BOARD ACTION REPORT – APPEALABLE ITEM

Project Name: 1236 George Bush Blvd
Project Location: 1236 George Bush Blvd
Request: Class V Site Plan
PCN: 12-43-46-09-39-000-0281
Board: Site Plan Review and Appearance Board
Meeting Date: May 25, 2022
Board Action: 6 – 1 Annette Gray dissenting)
Brief Description: Class V Site Plan and architectural elevations for a proposed a 6-unit townhome development and landscape waiver.

SITE PLAN REVIEW AND APPEARANCE BOARD STAFF REPORT

1236 George Bush Blvd.

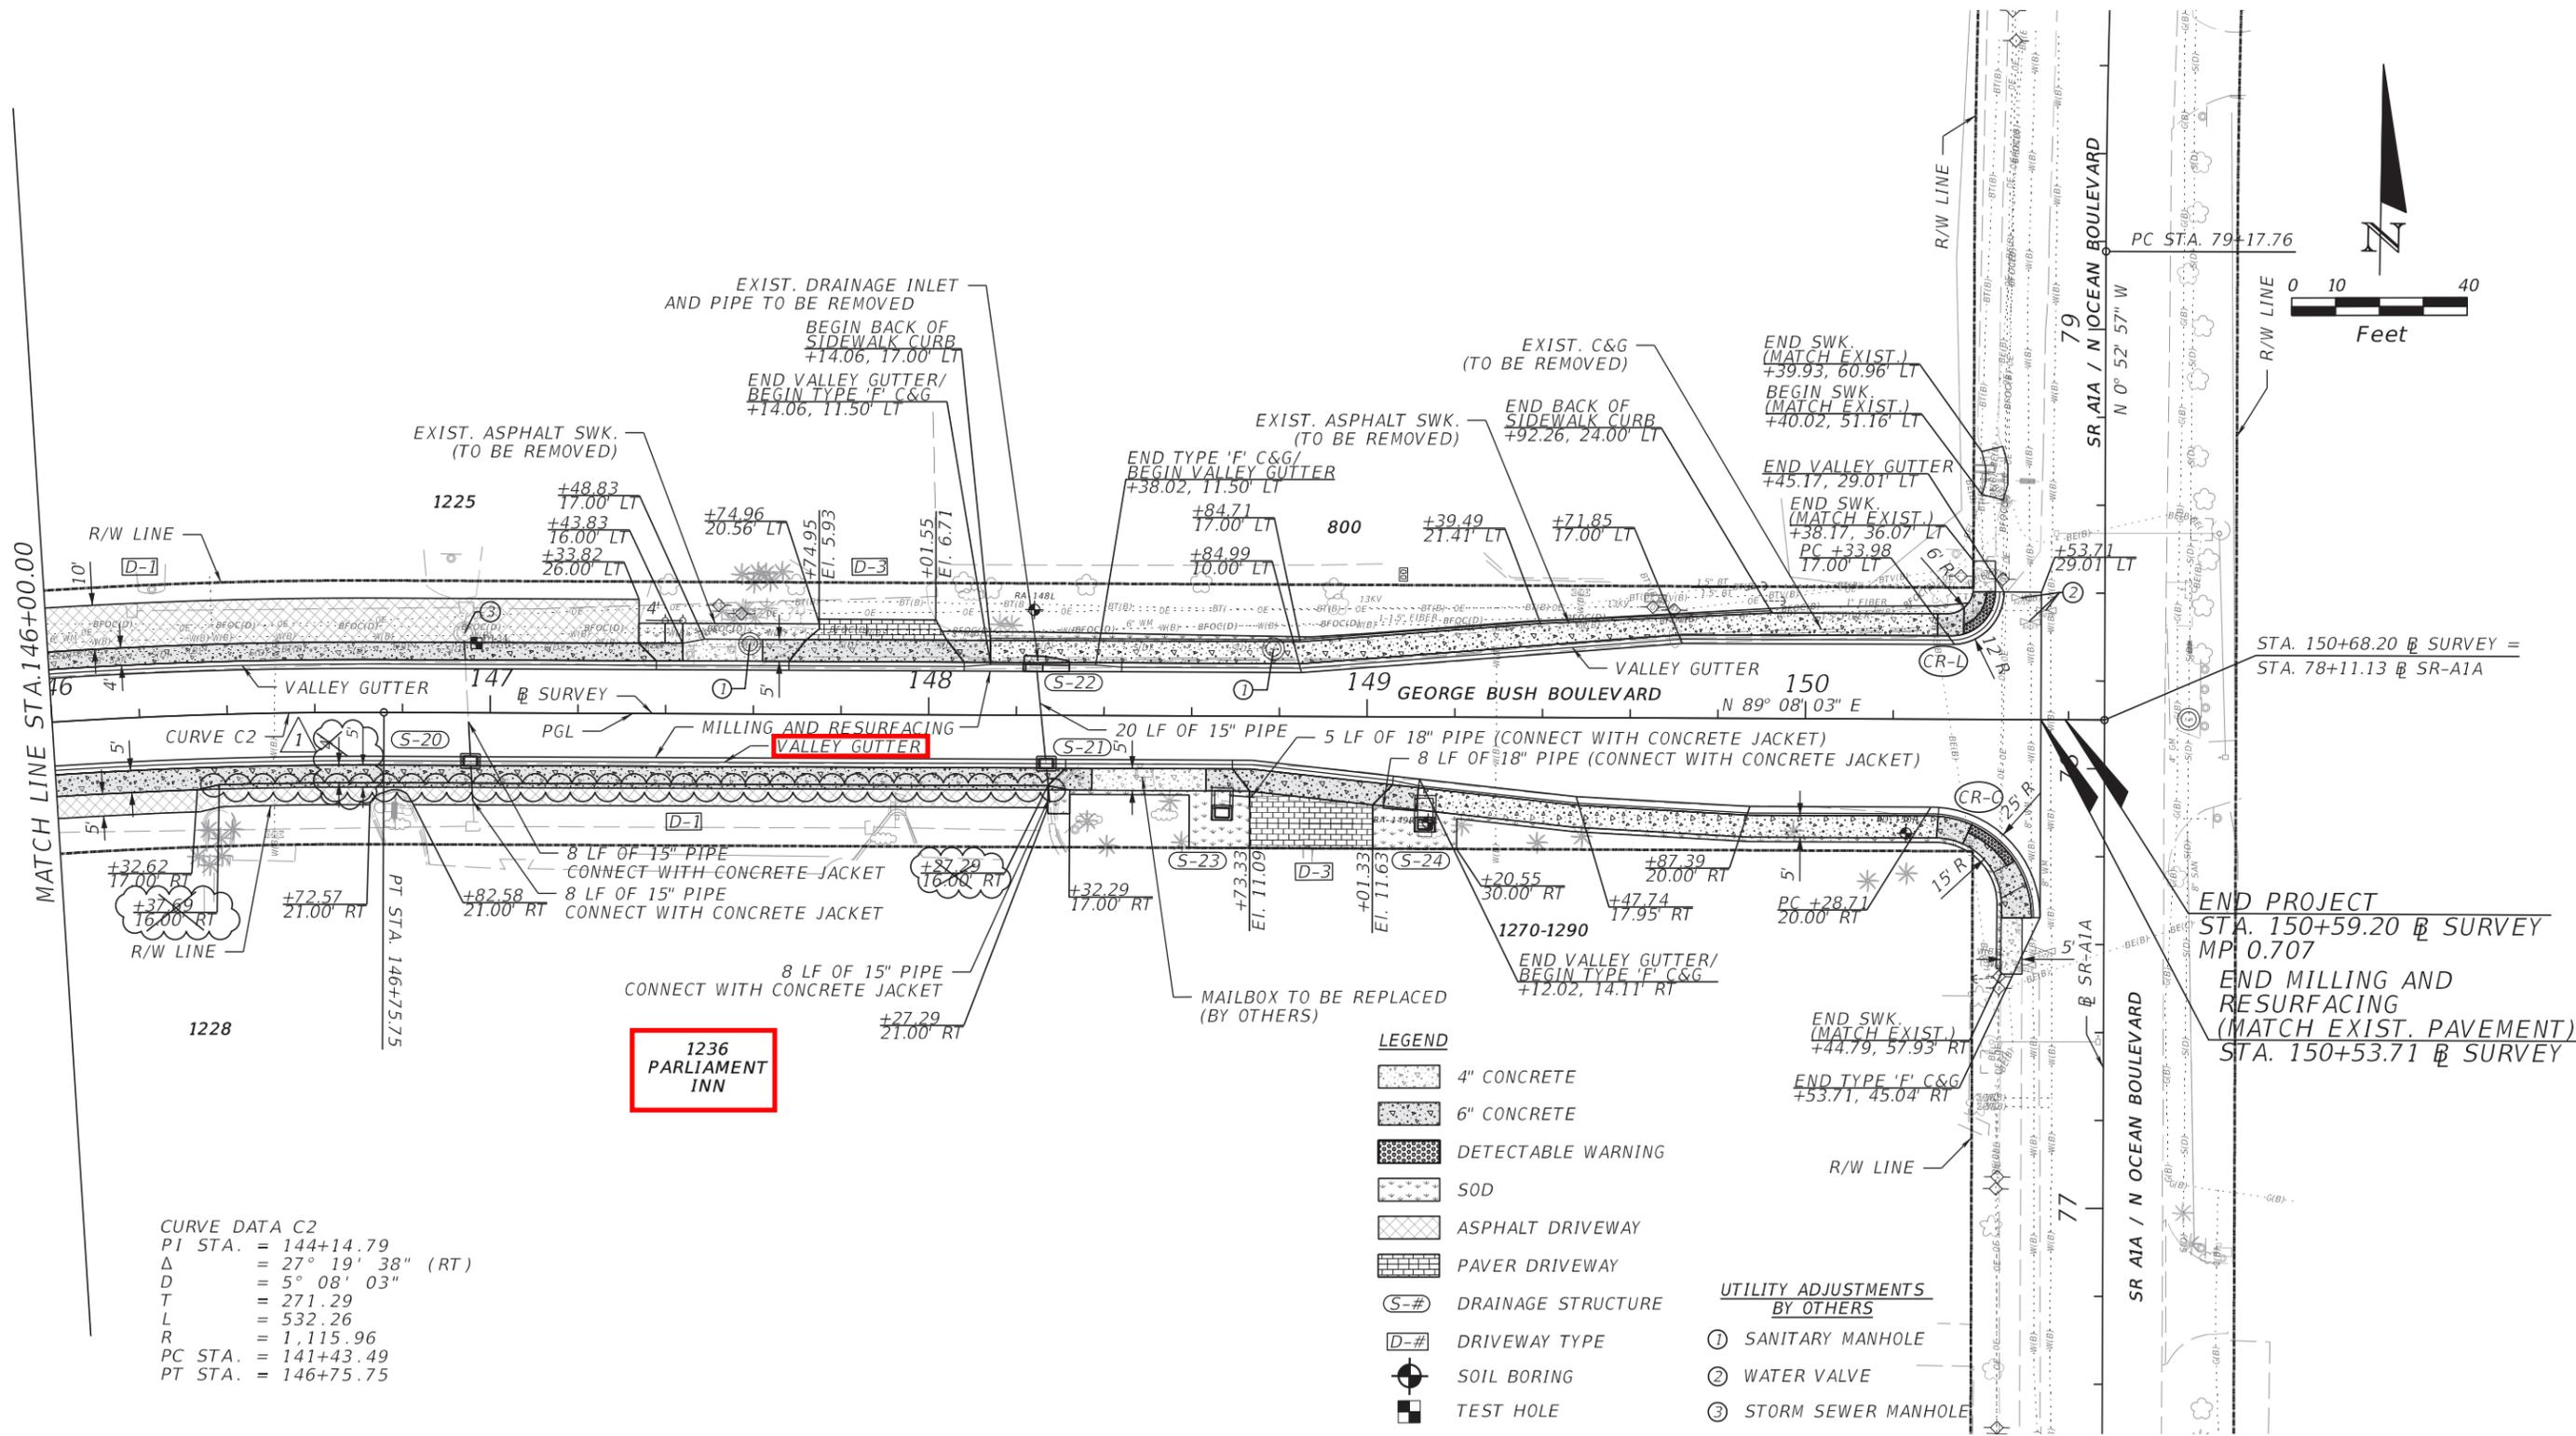
The Property is located on George Bush Boulevard east of the intracoastal waterway, along which FDOT has proposed a valley gutter system (FDOT Roadway Plan dated 12/3/21 attached hereto as Exhibit A). The valley gutter is to be located along the frontage of the Property.

At the proposed alternative 4' offset, the installation of an F or D curb would be necessary to comply with the requirements of the FDOT Greenbook. An F or D curb, however, would conflict with the current FDOT Roadway Plan (Exhibit A), providing for a valley gutter. The installation of an F or D curb would further interfere with ingress and egress from the residences. As shown on the Site Plan, there are to be six (6) driveways along the frontage of the Property. An F or D curb cannot be placed within any of the driveways, requiring a valley gutter for vehicular access. Even assuming some allowance by FDOT for an F or D curb at the location (which has not been provided) such a modification would be highly impractical resulting in only a very minimal percentage of the frontage to provide for the raised curb, rendering the placement and location of the trees meaningless to the intent of the applicable landscape regulation purpose.

EXHIBIT B

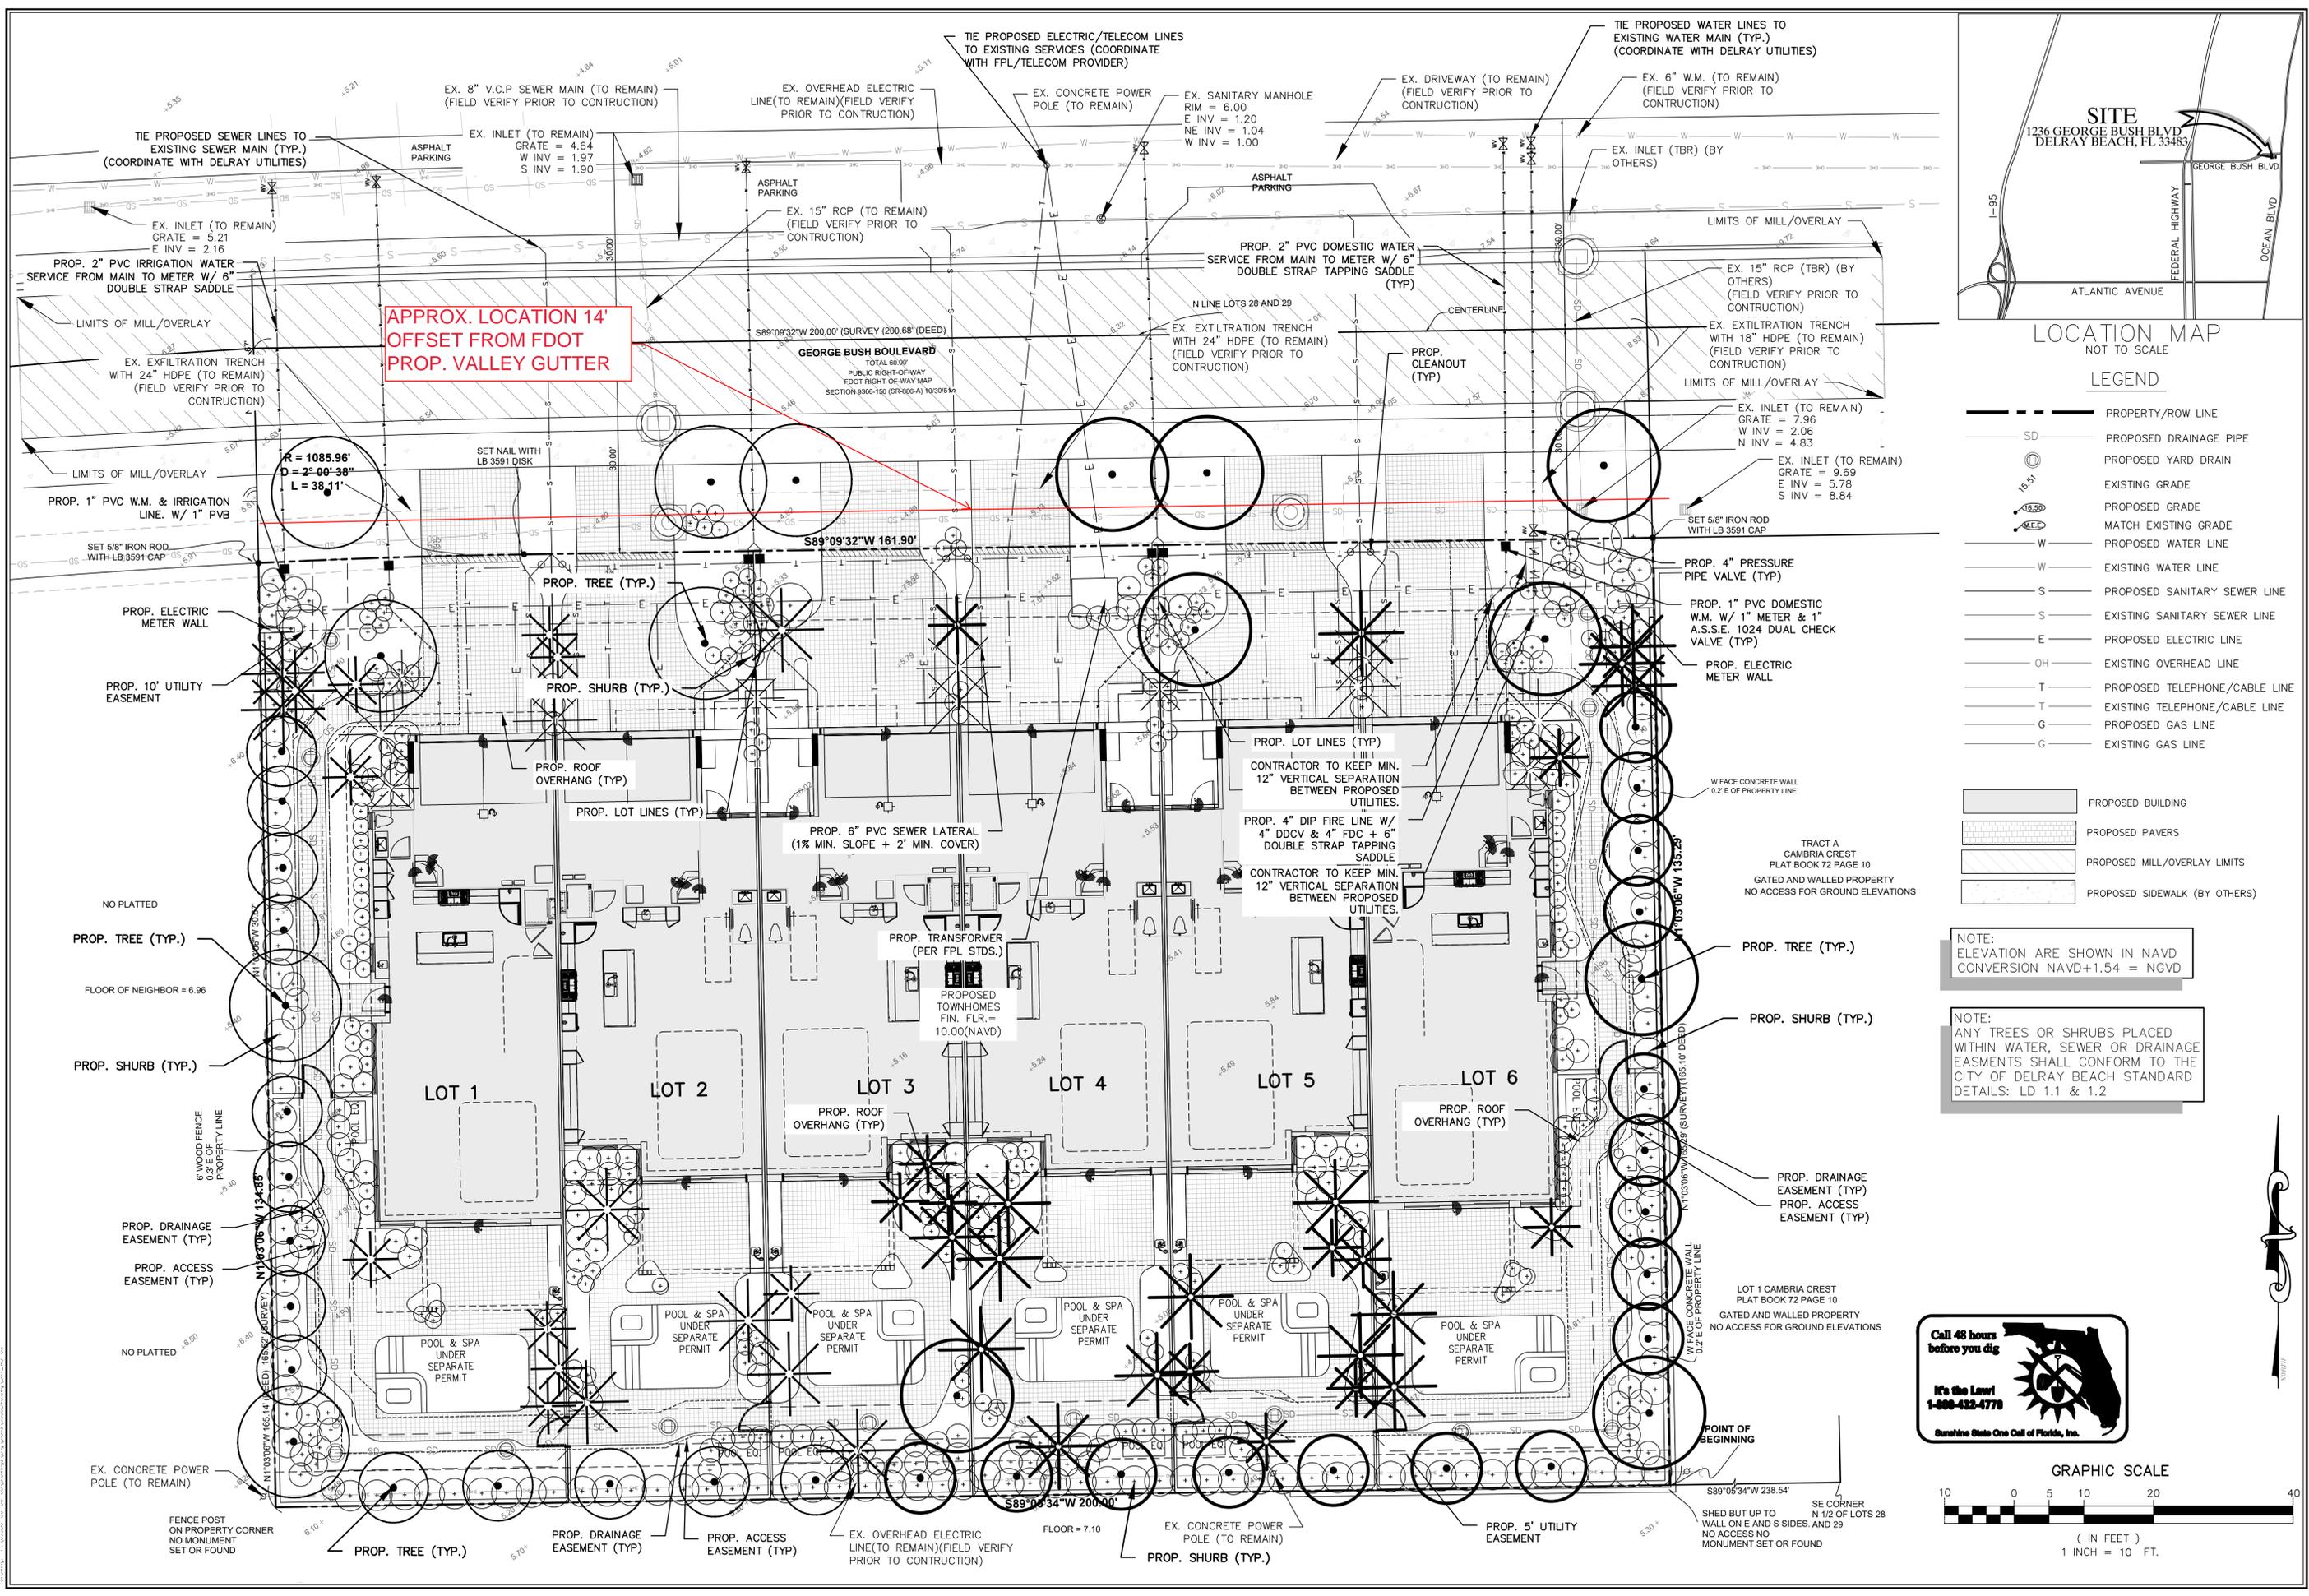
31. Please adjust the street trees to be at least 14' from the edge of traveled way or provide raised curbs to adjust the required offset to 4' from face of curb to comply with horizontal offset requirements as established in the Florida Greenbook.

The Property additionally contains a City of Delray Beach installed exfiltration trench at the 14' offset mark from George Bush Boulevard (See Site Plan for the Property showing exfiltration trench, Exhibit B).

At the proposed 14' offset, trees would sit directly over the existing exfiltration trench. The placement of any type of tree within the exfiltration trench would interfere with the operation of the exfiltration system. The placement of trees at the 14' offset mark would damage the system creating a hazardous condition not otherwise present at the Property. Trees are already located in the frontage of the Property as are shown on the Site Plan, thus defeating any purpose of a further retreat of the offset. A greater offset would also overstep the footprint of the improvements to be located on the Property, interfering with the buildable footprint of the proposed residences.

As set forth herein, the Offset Requirement cannot and should not be applied to the Property and a waiver is appropriate to permit the *omission of the requested street trees* in that: (1) trees placed 14' from the roadway will interfere with and obstruct the City's existing exfiltration trench stone and piping on site; and (2) the adjustment of the required offset to 4' from the face of curb would require a change of design to an F or D curb at the site, in conflict with the FDOT's current incorporation of a valley gutter into the road improvement design along George Bush Boulevard.
